Invitation of Public Comments

Sub: Four laning with paved shoulder of section from Km 53.600 (Gola on NH-320) to Km 1.446 (Ormanjhi on NH-320B) in the State of Jharkhand on Hybrid Annuity Mode: Permission for "Laying of IOCL's 8.625" OD Natural Gas Pipeline along with OFC across NH-320B at CH 68/150.

Sub: Four laning with paved shoulder of section from km 53.600 (Gola on NH-320) to km 1.446 (Ormanjhi on NH-320B) in the state of Jharkhand on Hybrid Annuity Mode. **Permission for "laying of IOCL's 8.625" OD Natural Gas Pipeline along with OFC across NH-320B at Ch. 68/150.**

STANDARD HDD SKETCH FOR NH-320B CROSSINGS

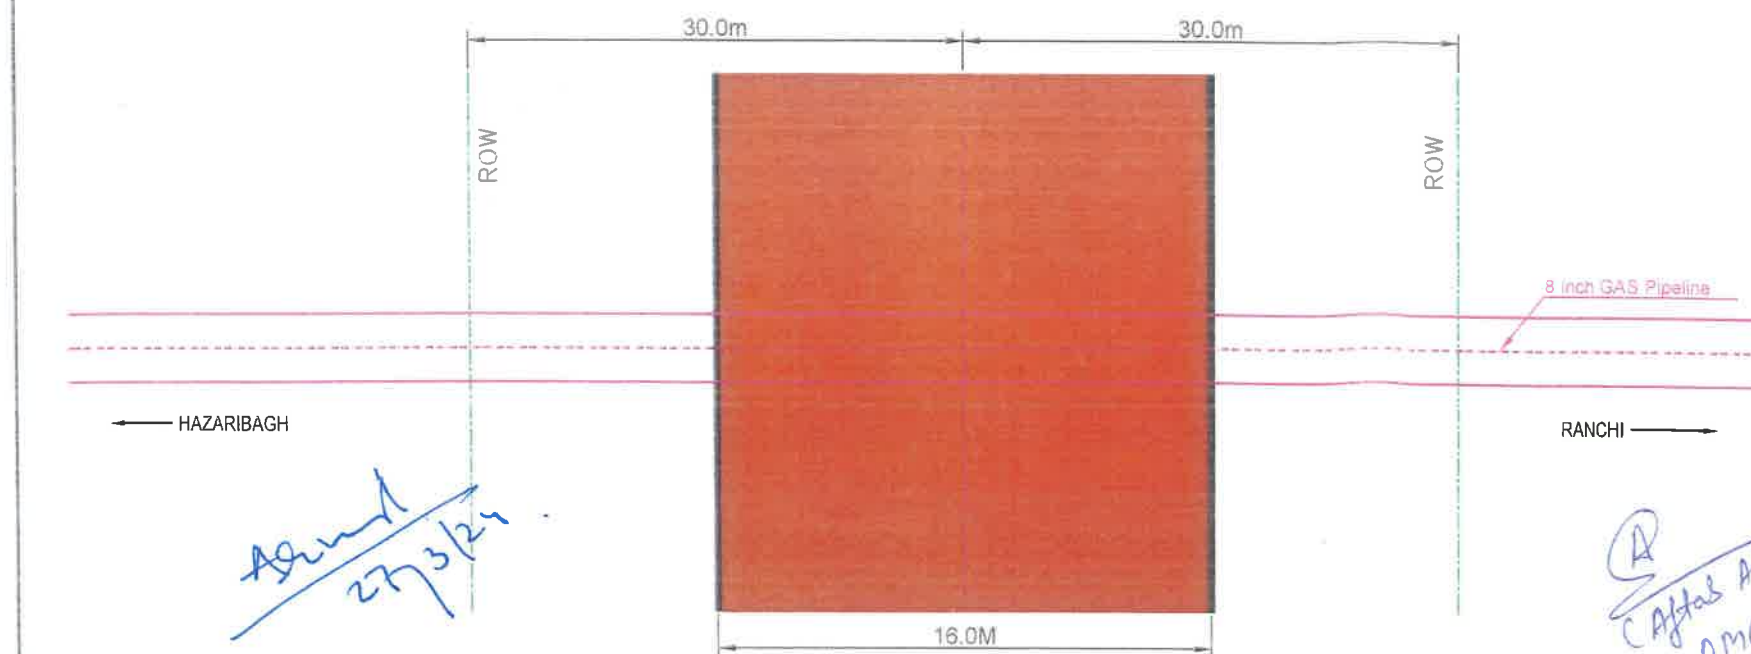
It is to intimate that that the said Gas pipe line is across the highway at km 68+150 (1-locations). The proposal has been examined with respect to ministry circular dated 22/11/2016 with following comments:

1. Methodology has been submitted by the agency and for laying the utility across highway HDD method is proposed with Depth of pipeline below 1.5 meter minimum from natural ground level.
2. The agency has submitted the undertaking that safety clearance from pollution control board and PESO (petroleum and explosive safety organization) will be submitted after obtaining clearance and cannot be submitted at this stage.
3. In case of shifting of Pipe line in future while developing 6 lane or for any other case IOCL will shift/remove immediately the pipe line on its own cost without asking any reason from NHAI.
